Determination Report

Determination of the JI Track-1 Project
in the Ukraine:
**«Rehabilitation of the District Heating
System in Kharkiv City»**

REPORT NO. 1201751

December 16, 2008

Fig. 1 Investment and return on Investment (fuel / power savings and ERUs revenues), in ths. EUR

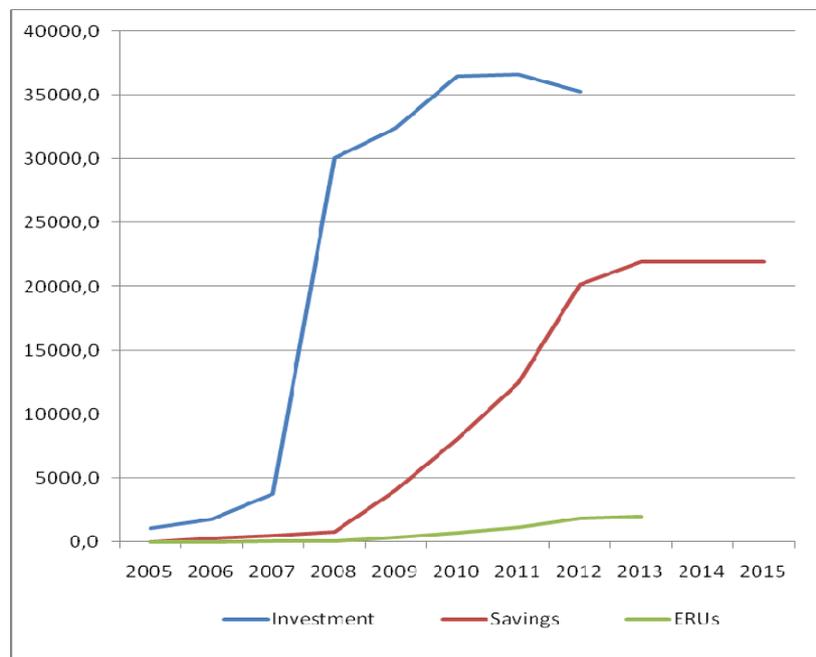
The investment analysis (Step 2) of the additionality tool is not applied. The barrier analysis (step 3) already demonstrates the additionality of the project to the full extent.

Anyway, calculation spread sheets (relevant Appendixes 7 and 9) were provided to the AIE for review and were analyzed carefully. ERUs revenues (2008-2012) build up approx. 5% of total investment cost and not affect IRR significantly. Theoretically, carbon credits could not be considered as reasonable source of project financing; and this project (as demonstrated per graphic **Figure 1**) is financially pretty attractive also without consideration of JI component (refer also to **CAR15**).

Real benefits are saving of fuel and power, efficiency increasing (new burner and CHP units) and just because of higher heat calorific value of natural gas (for fuel switch measurements at some boilers). Further information on exact figures is provided in Appendix 9.
